中華電力有限公司
CLP Power Hong Kong Limited

Code of Practice 101 for Distribution Substation Design (COP101)
Update No. 4/2019 – New and Revised COP101 Drawings

Document:	COP101 Version 14
Effective Date:	10 December 2019
Summary of Change:	New and revised COP101 drawings are listed below and attached. 1. Revision of drawing - T-COP-10250-D-E33-0102-03-E-A (Concrete wall or steel supporting structure added to optimise cable routing.) 2. Revision of drawing - T-COP-10250-D-E33-0102-04-E-A (Concrete wall or steel supporting structure added to optimise cable routing.)) 3. Revision of drawing - T-COP-10250-D-E33-0103-16-E-A (Dimension of wicket door added.) 4. Revision of drawing - T-COP-10250-D-E33-0103-17-E-A (Dimension of wicket door added.) 5. Revision of drawing - T-COP-10250-D-E33-0103-18-E-A (Dimension of wicket door added.) 6. Revision of drawing - T-COP-10250-D-E33-0103-19-E-A (Dimension of wicket door added.) 7. Revision of drawing – T-COP-10250-D-E33-0103-29-B-A (Outlet of temporary supply cables updated.) 8. New drawing – T-COP-10250-D-E33-0103-40-A (Typical details of eyebolt Installation for L.V. board)

DRG. NO. T C O P 1 0 2 5 0 D E 3 3 0 1 0 4 0 7 G A

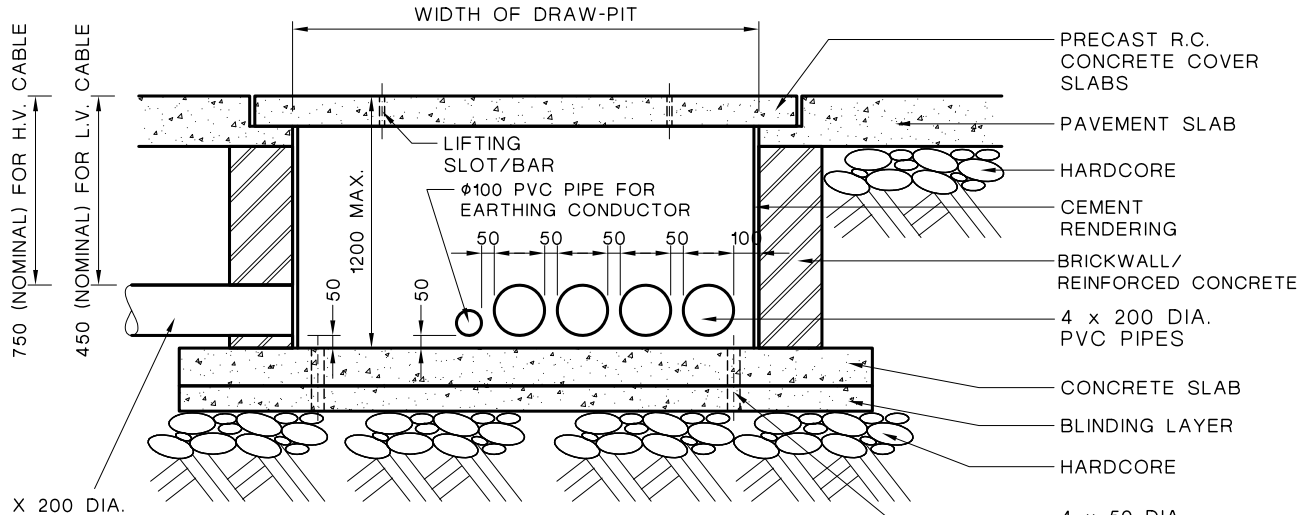
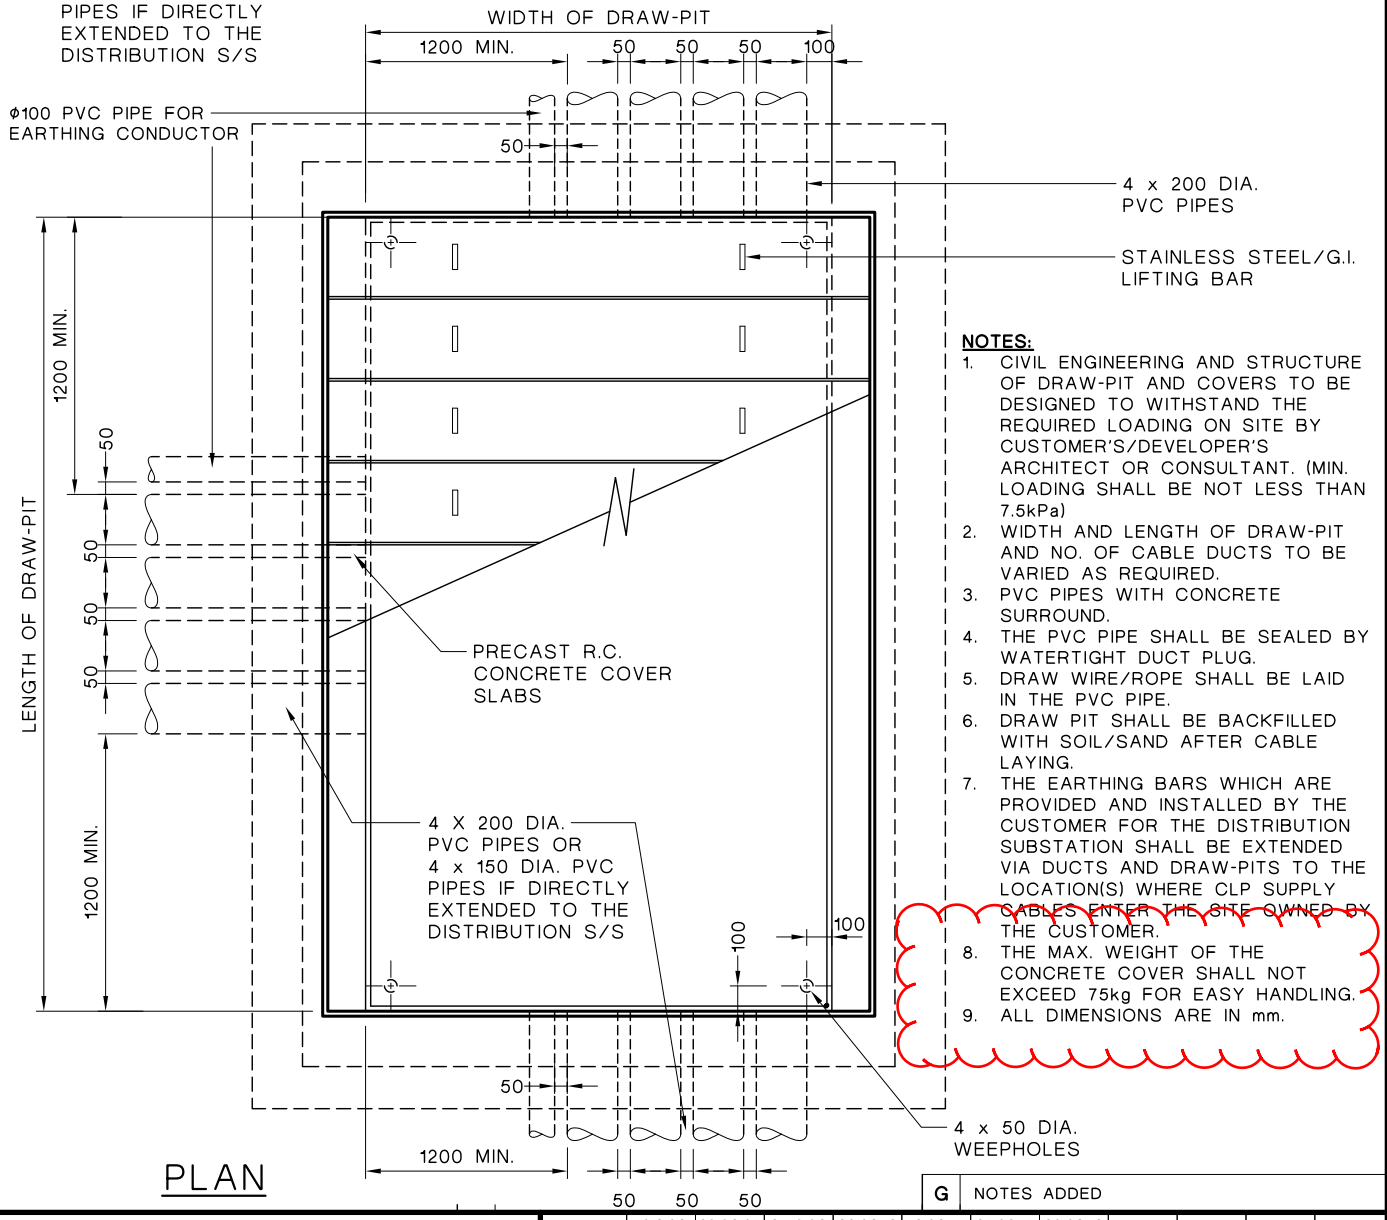
G	NOTES ADDED

DRG. NO. T C O P 1 0 2 5 0 D E 3 3 0 1 1 2 0 3 A A

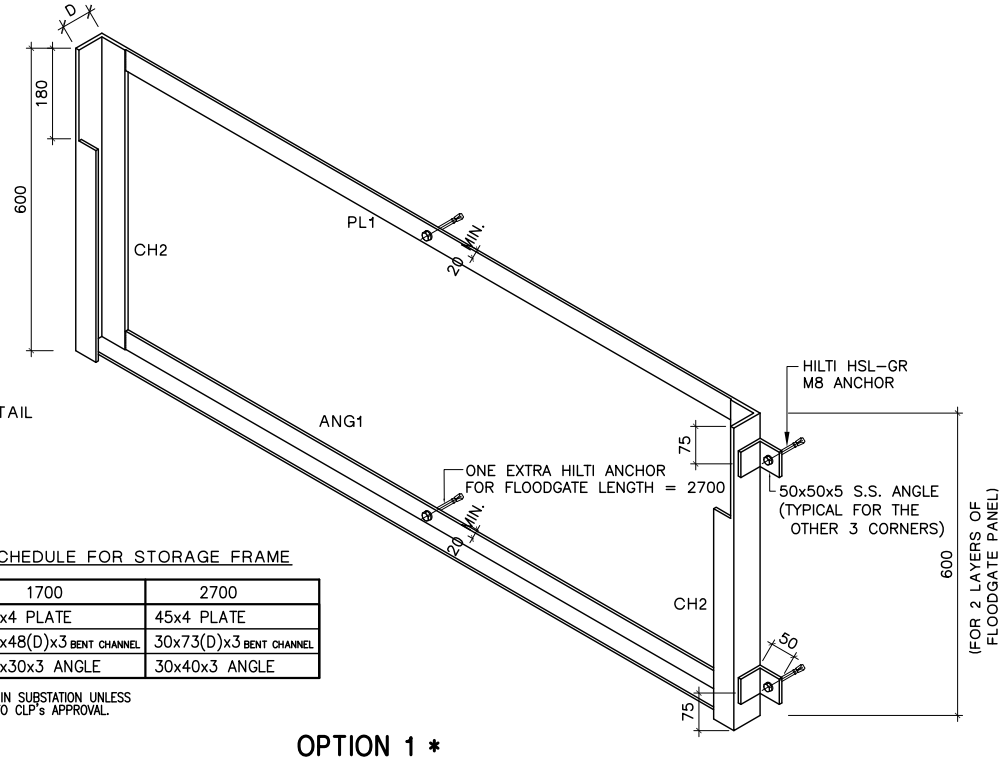
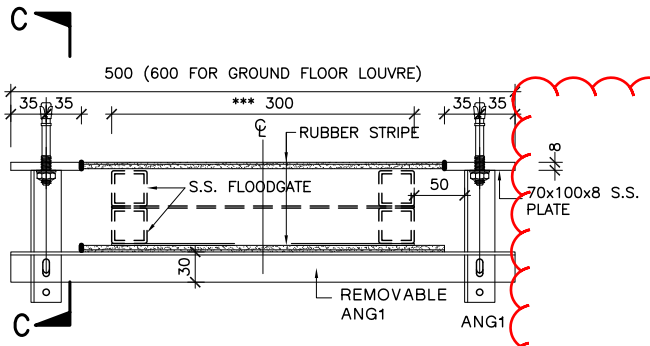
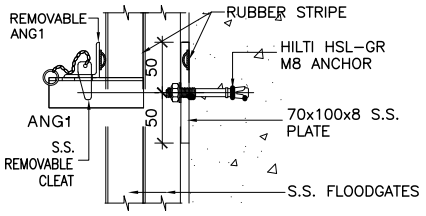
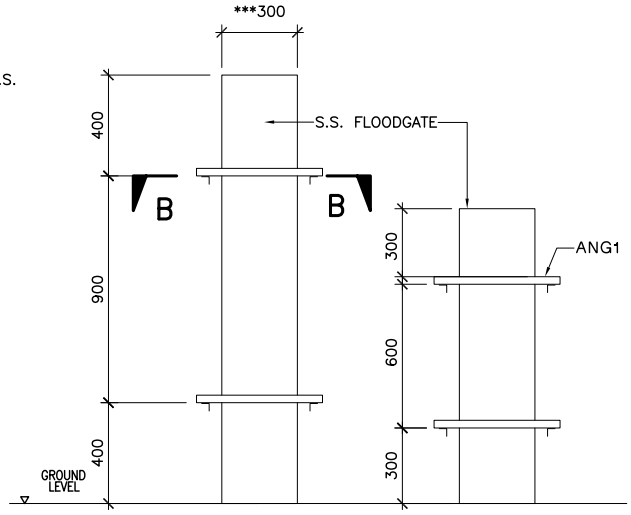
9. New drawing – T-COP-10250-D-E33-0103-41-A (Typical details of double leaf laminated steel door with shut bolt) 10. New drawing – T-COP-10250-D-E33-0103-42-A (Typical details of single leaf laminated steel door with shut bolt) 11. Revision of drawing – T-COP-10250-D-E33-0104-04-C-A (Note added.) 12. Revision of drawing – T-COP-10250-D-E33-0104-05-E-A (Note added.) 13. Revision of drawing – T-COP-10250-D-E33-0104-06-F-A (Note added.) 14. Revision of drawing – T-COP-10250-D-E33-0104-07-G-A (Note added.) 15. Revision of drawing – T-COP-10250-D-E33-0112-03-A-A (Vertical storage frame arrangement for 2700 length floodgate is deleted.)

A	VERTICAL STORAGE FRAME ARRANGEMENT FOR 2700 LENGTH FLOODGATE IS DELETED.
